Project	IEEE 802.16 Broadband Wireless Access Working Group < http://ieee802.org/16 >	
Title	Extension of collaborative spatial multiplexing in OFDMA	
Date Submitted	2005-01-10	
Source(s)	Bin-Chul Ihm, Yongseok Jin, Jinyoung Chun, Kyuhyuk Chung	Voice: 82-31-450-7187 Fax: 82-31-450-7912
	LG Electronics, Inc. 533, Hogue-1dong, Dongan-gu, Anyang-shi, Kyongki-do, Korea	[mailto: {bcihm, jayjay, jychun03, kyuhyuk} @lge.com]
	Ran Yaniv, Tal Kaitz	[mailto: {ran.yaniv, tal.kaitz} @alvarion.com]
	Alvarion Ltd.	
Re:	This is a response to a Call for Comments on IEEE P802.16e-D5a	
Abstract	The collaborative spatial multiplexing can be applied to the case in OFDMA.	
Purpose	This document is submitted for review by 802.16e Working Group members	
Notice	This document has been prepared to assist IEEE 802.16. It is offered as a basis for discussion and is not binding on the contributing individual(s) or organization(s). The material in this document is subject to change in form and content after further study. The contributor(s) reserve(s) the right to add, amend or withdraw material contained herein.

Extension of Collaborative Spatial Multiplexing in OFDMA

Figure 2. The case of two SSs with dual transmit antennas

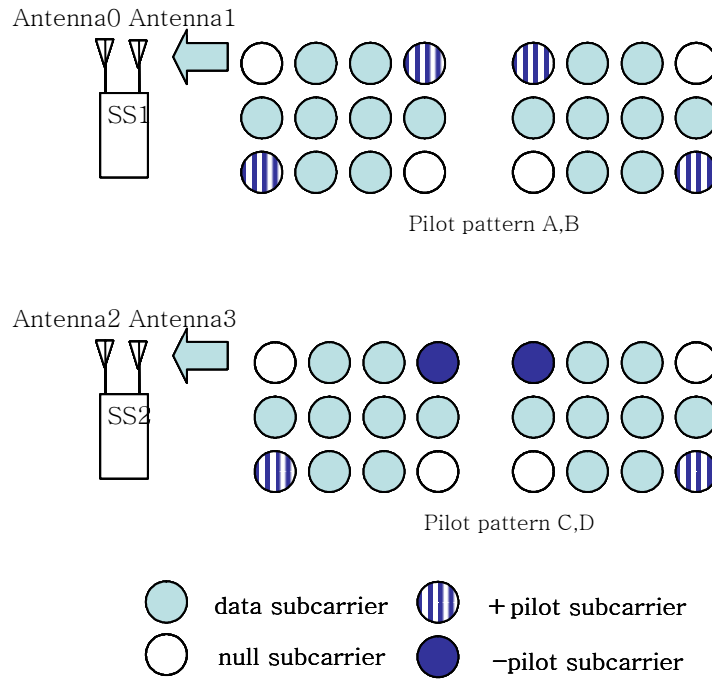
The second example of the aforementioned collaborative SM examples requires four pilot patterns to distinguish the channels from each antenna of MSSs. For the purpose of realizing the above configurations, more pilot patterns are needed to support the various collaborative SM modes. Therefore, we propose to add new pilot pattern C, D to current pilot pattern A, B as shown in Figure 2.

[Figure 249a – Pilot Patterns in UL PUSC tile](#)

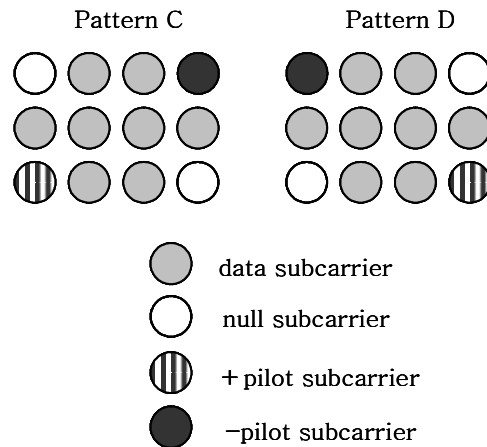
[Insert Figure 249a after Figure 249 as follows:]

Two single transmit antenna SS's can perform collaborative spatial multiplexing onto the same subchannel. In this case, the one SS should use the uplink tile with pattern-A and the other SS should use the uplink tile with pattern-B. [Also, two dual transmit antenna SS's can perform collaborative spatial multiplexing onto the same subchannel. In this case, the one SS should use the uplink tile with the pilot pattern A, B and the other SS should use the uplink tile with the pilot pattern-C, D through MIMO UL Basic IE. Pilot patterns are illustrated in the Figure 249 and 249a.](#)
